Update on the ADA Accessibility Parking at Forrester Park and Three Weirs Park Project

Town staff will present the ADA Accessibility Parking at
Forrester Park and Three Weirs Park Project to the Town
Council. Design options and revisions include:
1. Parallel Accessible Parking Stalls

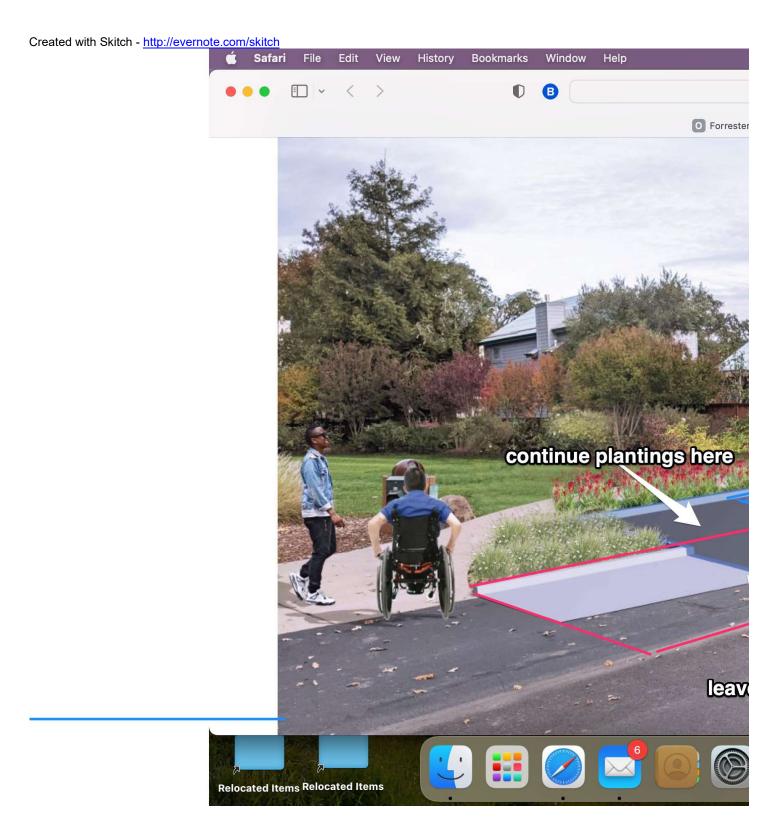
And finally, regarding Forrester Park, in Plan 2, I sent in a question asking if the the ADA parking space could be moved to the south so that we could keep on parking spot in front of Forrester Park and add the ADA space, instead of locating the ADA parking spot in the middle thereby losing a general parking space.

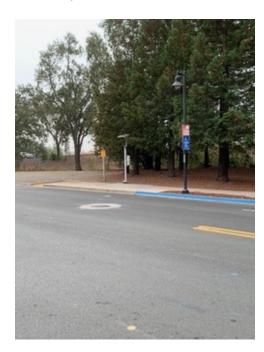
My last suggestion for the recent design update is to move the ADA parking space to the right, as close as possible to the existing light post, so that the access is as short as possible and right next to the ADA ramp and pathway to the park.

That way there will still be a general public parking space in front of the park on the left side of the ADA spot without blocking that north pathway into the park. As shown now a person could park on the parking shoulder on either side of the ADA spot and block access to the pathway. By moving the ADA spot south it would eliminate that possibility on the right side completely so that no one blocks the ADA access, and open up a spot for a well used parking space.
